REZONING APPLICATION: PD 22-0948
ZONING HEARING MASTER DATE: FEBRUARY 20, 2023
BOCC LAND USE MEETING DATE: APRIL 11, 2023

AGENCY REVIEW COMMENT SHEET

Application number:	RZ-PD 22-0948
Hearing date:	February 20, 2023
Applicant:	Omar Chaudry
Request:	Rezone to Planned Development
Location:	12850 South U.S. Highway 301, Riverview
Parcel size:	3.94 acres +/-
Existing zoning:	AS-0.4
Future land use designation:	R-4 (4 du/ga; 0.25 FAR)
Service area:	Urban Services Area
Community planning area:	Riverview Community Plan and South Shore Areawide Systems Plan

DRAWING NO. **TS-7**
SHEET NO. 1 OF 1

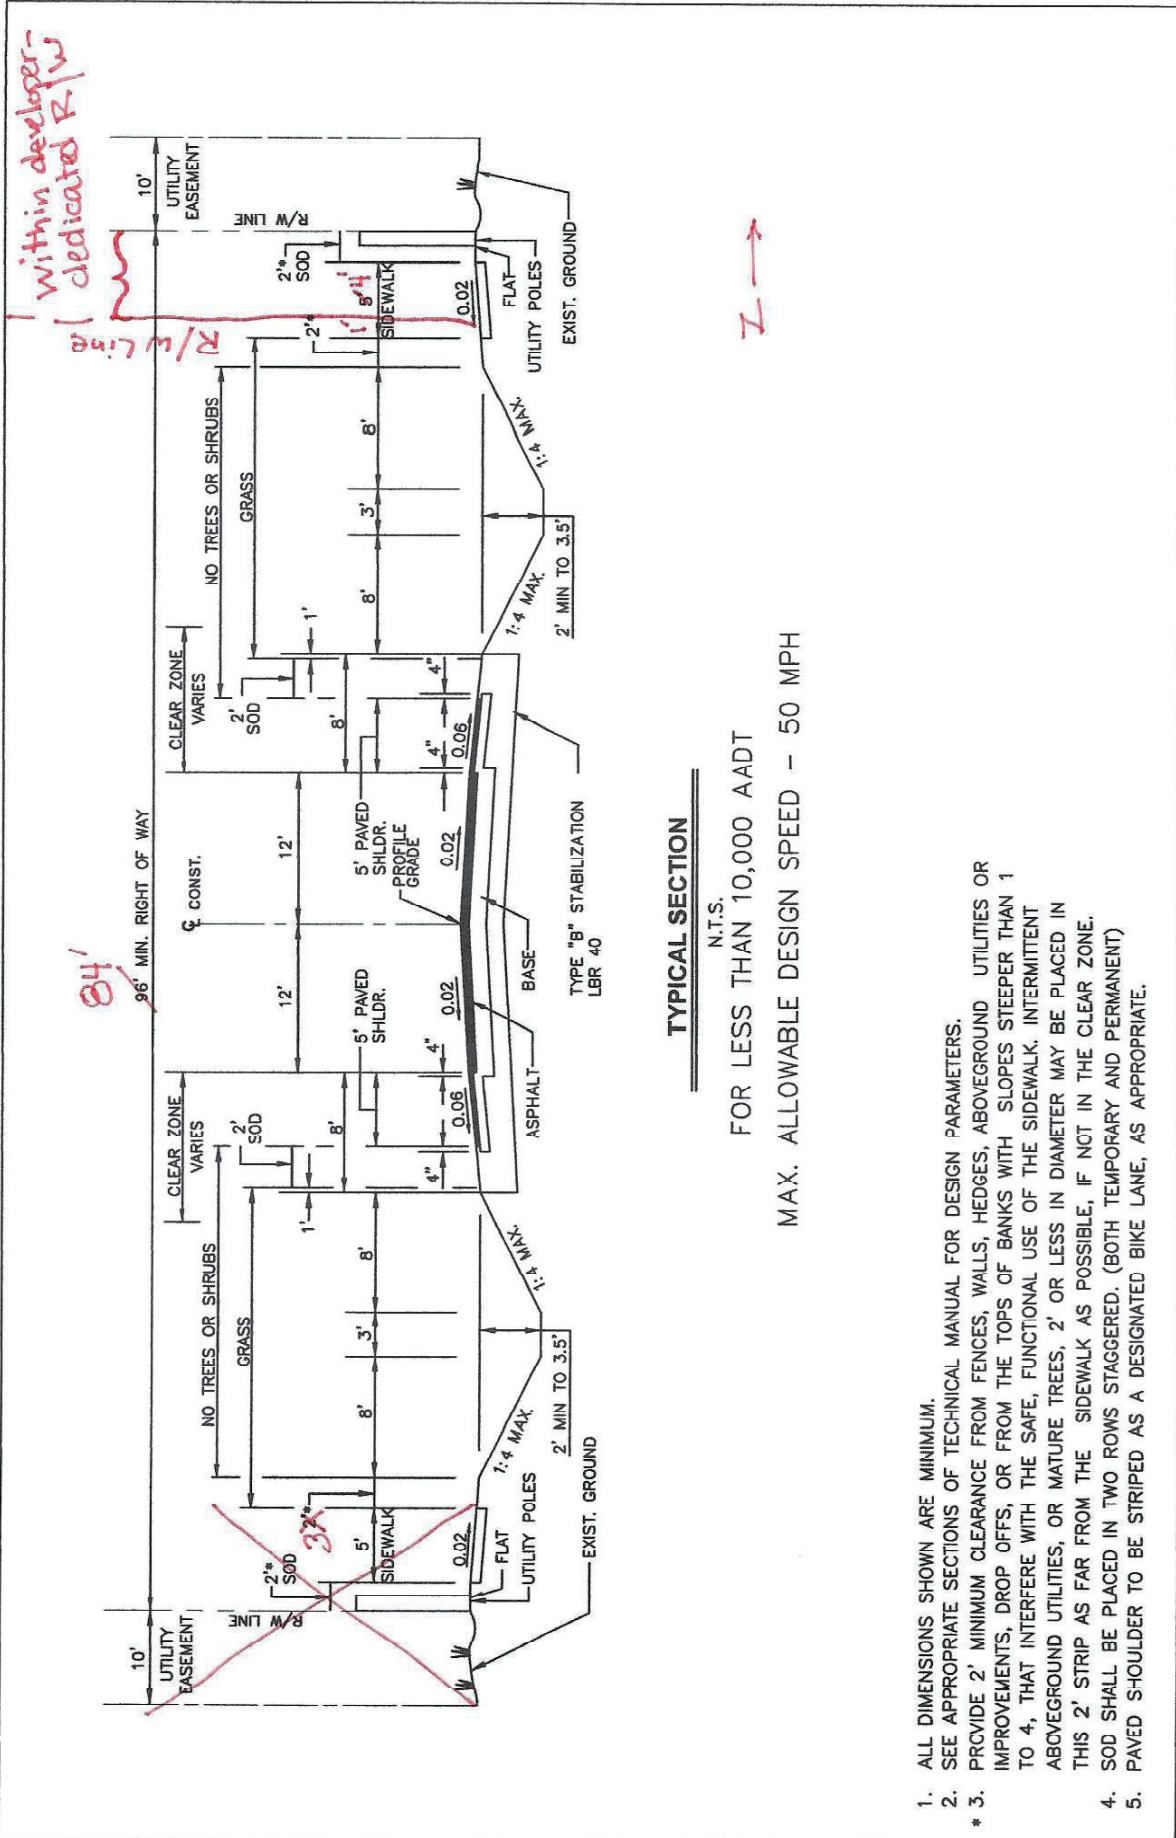
*PROPOSED IMPROVEMENTS – A modified TS-7 is proposed, as is shown in the **Typical Section Exhibit**. The roadway will be improved, but not brought fully to TS-7 standards because a standard TS-7 section would require 96 feet of right of way.*

- Disapproved
- Approved with Conditions
- Approved

LOCATION MAP

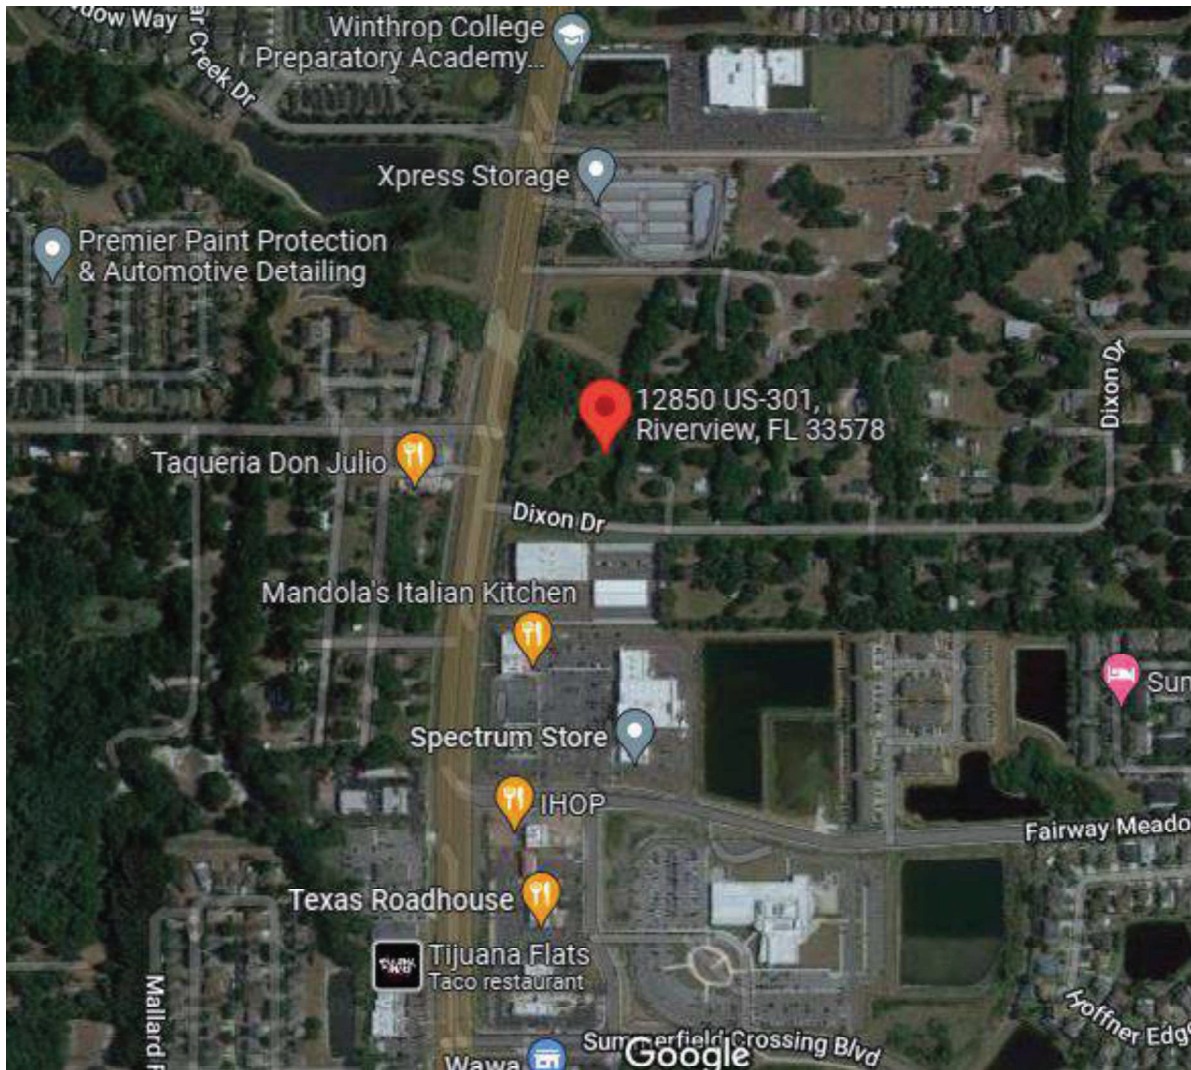
Fence line to fence line relative to the parcel just to east, there is 86 feet of ROW – this corresponds to the approximately 85 feet shown on Hillsborough Mapper (See last exhibit).

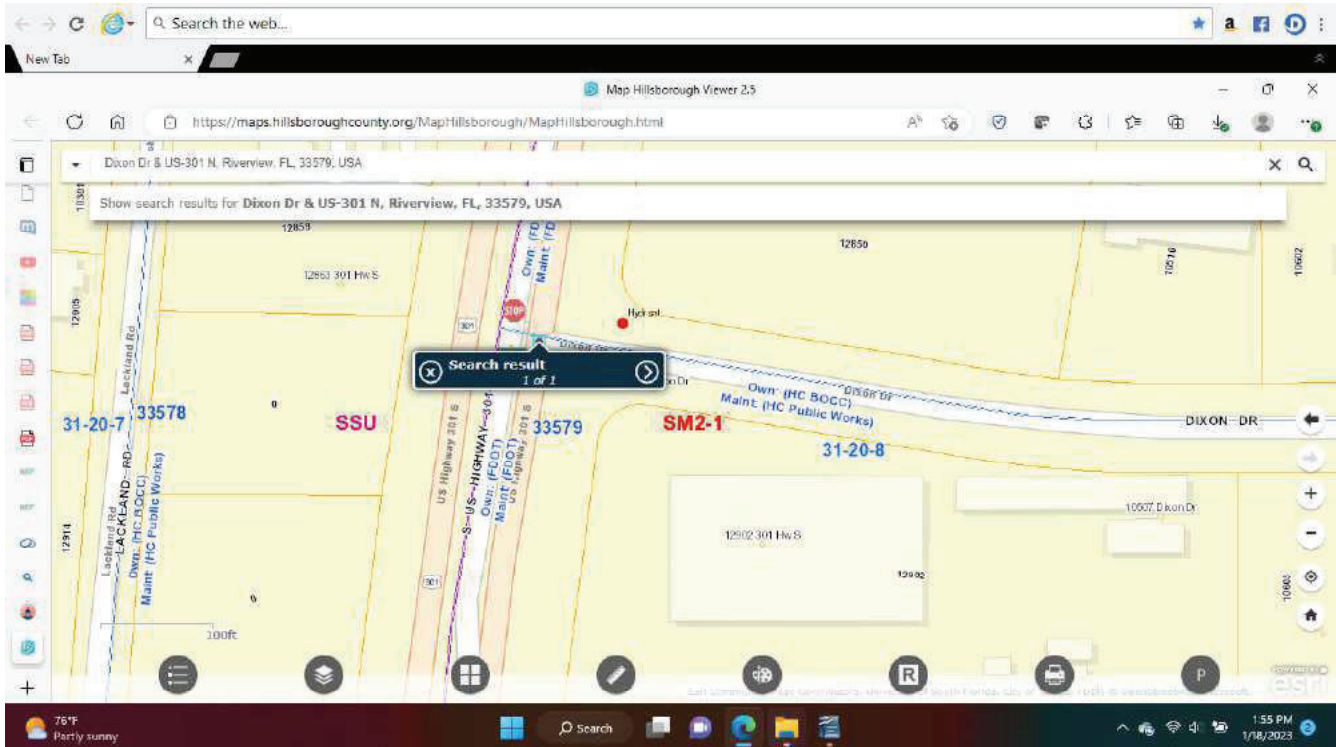
Utility pole on south side – 15' from edge of pavement of Dixon Drive

Dixon Drive – 18 ½ feet pavement width

2.4 Proposed Site Plan (partial provided below for size and orientation purposes. See Section 8.0 for full site plan)

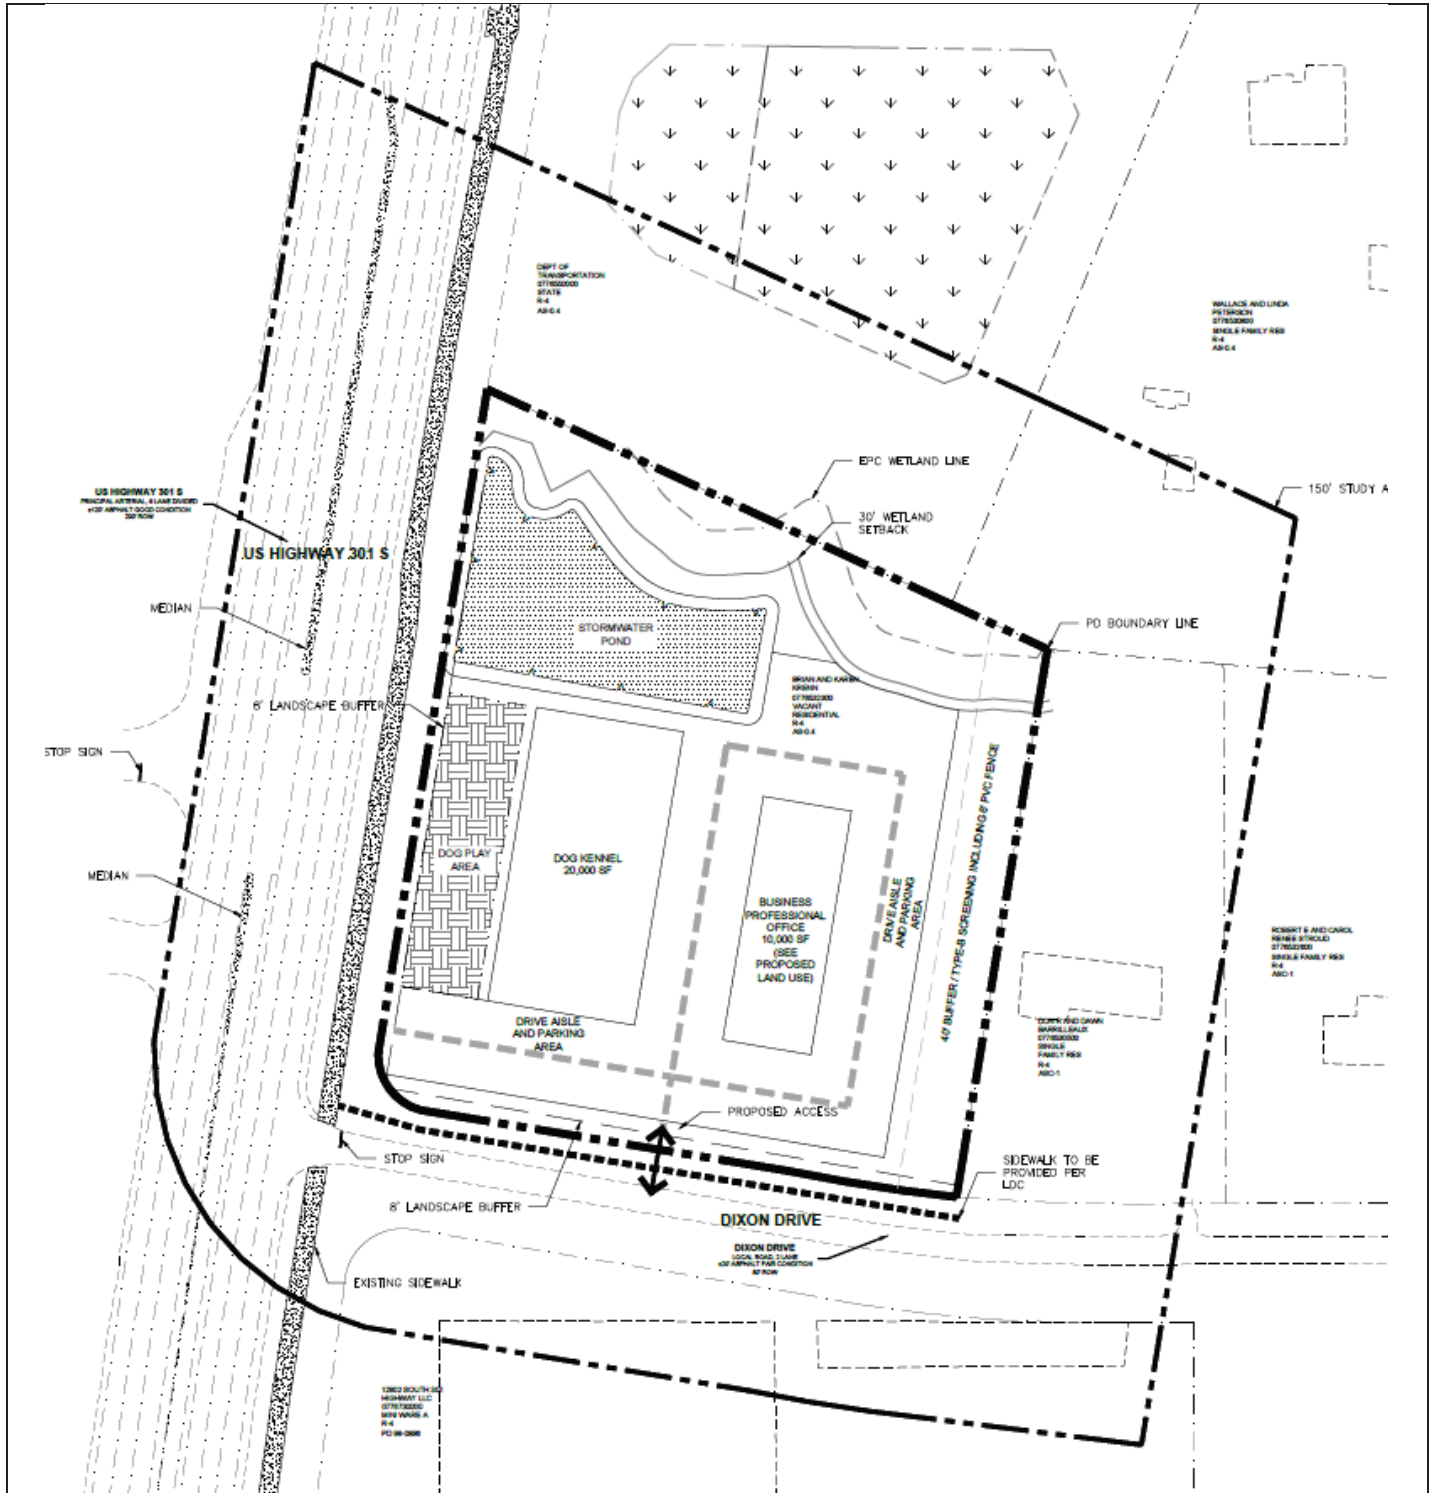
Prior to PD Site Plan certification, the applicant will depict the 6 feet of right of way along Dixon Dr. frontage that the applicant is proffering to dedicate as part of the submitted design exception.
